REDLAND HEIGHTS P.U.D.
PRELIMINARY OVERALL AREA DEVELOPMENT PLAN
No.

RE: Redland Heights PUD Subdivision POADP #389

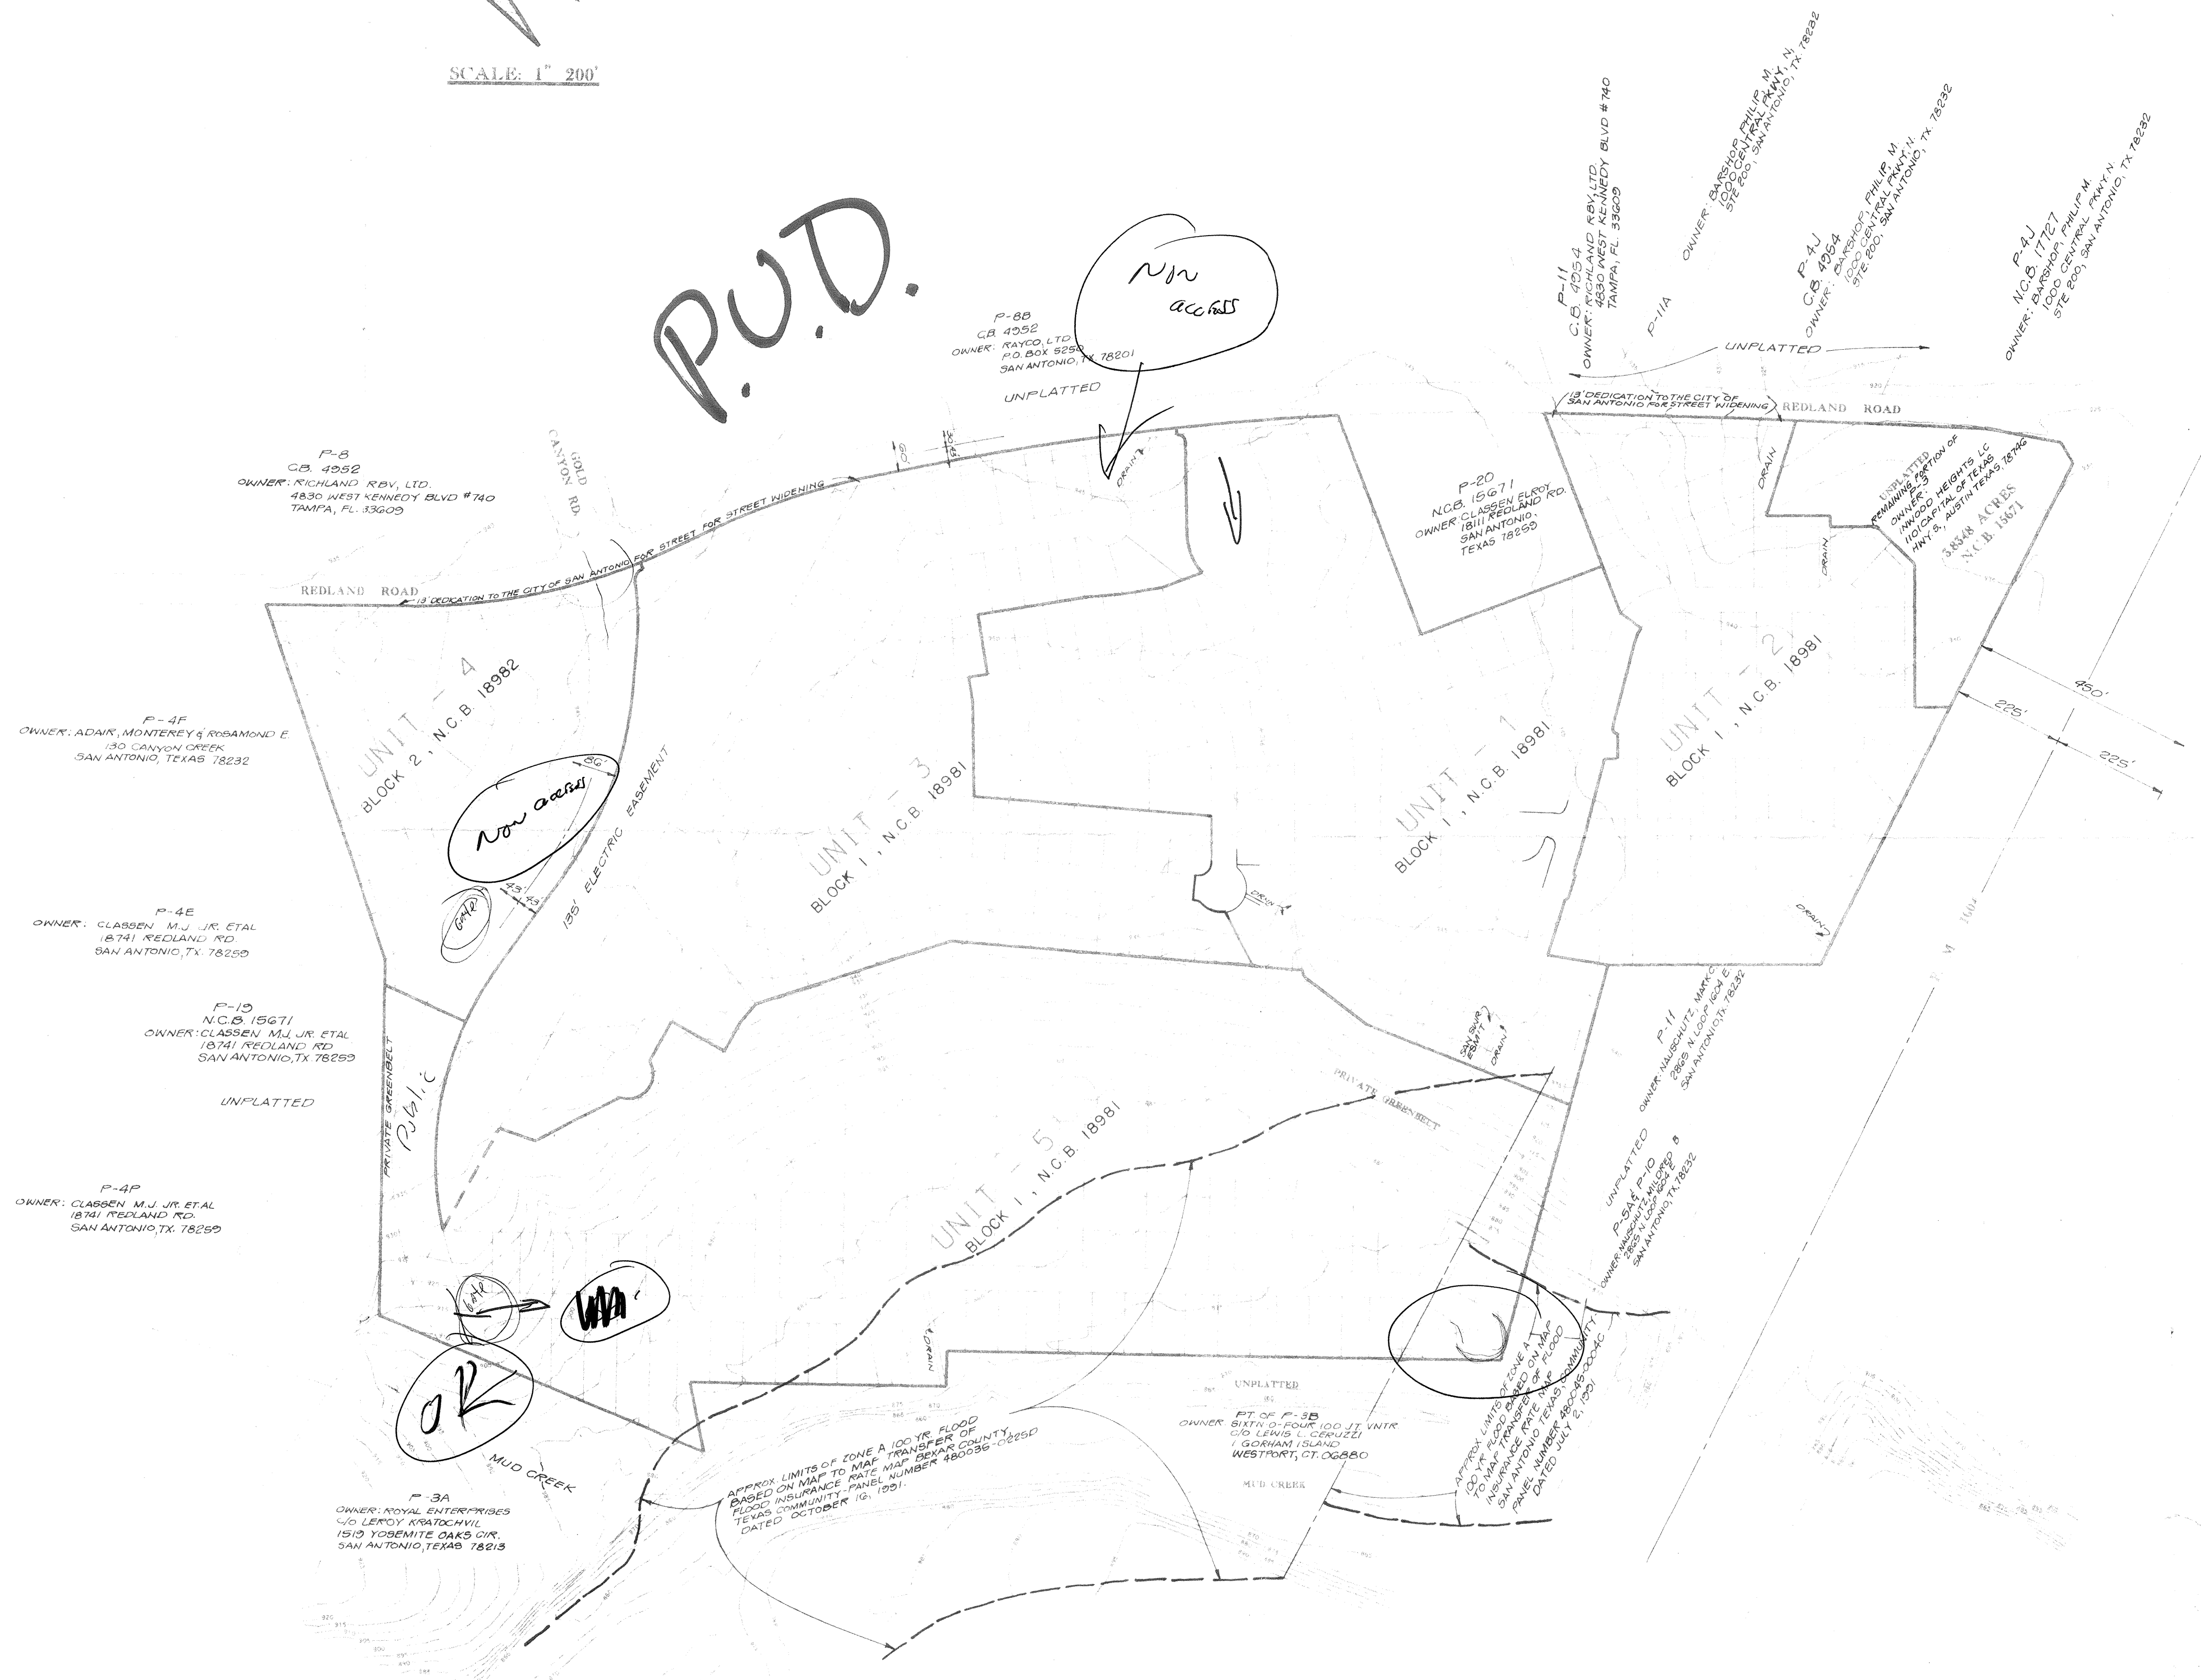
Although your plan was accepted, Please note the following:

1. A non-access easement will be required along the western ROW of Redland adjacent to all residential lots at the time of plat submittal.
2. Gate detail needs to be submitted for all gate locations to the Traffic Planning Engineer. He needs to assess the potential stacking problems at each location.
3. Flood plain boundaries need to be established through delineation of the 100 year flood plain elevations and submitted to the Drainage Engineering Section for review.
